Access Compliance Report Public Rights-of-Way (Curb Ramps)

Intersection ID: 6370 Main Street: LAKE_RD **Cross Street: MILHAVEN_LN** Location: SE Severity Score: 21.25 **Overall Compliance: No ADA ID: 8E902F06FDE6** Ramp Type: Perpendicular Initial Pass/Fail: Fail

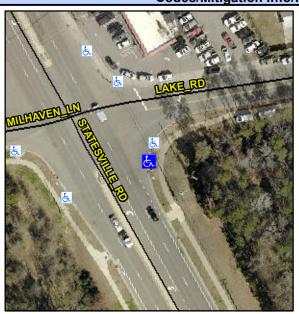
Possible Solutions: Remove & Replace Entire Ramp. Surveyor Notes: N/A PROW/ADA: Not Found, R304.5.1, R304.2.2

Field Measurements/Component Compliance							
Compl	iance Description	Data	Comp	liance	Description	Data	
N/A	Ramp Length (in)	105.0	No	Ramp	Slope (%)	8.8	
No	Ramp Width (in)	47.0	Yes	Yes Ramp XSlope (%)		1.6	
N/A	Flare Type LT	N/A	N/A	N/A Flare Type RT		N/A	
N/A	Flare Slope LT (%)	N/A	N/A	I/A Flare Slope RT (%)			
N/A	Flare Traversable LT?	N/A	N/A	Flare	Traversable RT?	N/A	
N/A	Landing Length (in)	N/A	N/A	DWS Provided?		N/A	
N/A	Landing Width (in)	N/A	N/A	DWS	Contrast?	N/A	
N/A	Landing Slope (%)	N/A	N/A	DWS	Length (in)	N/A	
N/A	Landing X Slope (%)	N/A	N/A	DWS	Full Width?	N/A	
N/A	Landing Curb? (Y/N)	N/A	N/A	DWS	Offset (in)	N/A	
N/A	Shared Landing?	N/A					
N/A	Gutter Ponding?	N/A	N/A	Gutte	r Slope (%)	N/A	
N/A	Gutter Lip Ht (in)	N/A	N/A	Gutte	r X Slope (%)	N/A	
N/A	Painted X Walk1?	No	N/A	Painte	ed X Walk2?	N/A	
	X Walk 1 Direction	To W		X Wa	lk 2 Direction	N/A	
N/A	X Walk 1 Width (in)	N/A	N/A	X Wa	lk 2 Width (in)	N/A
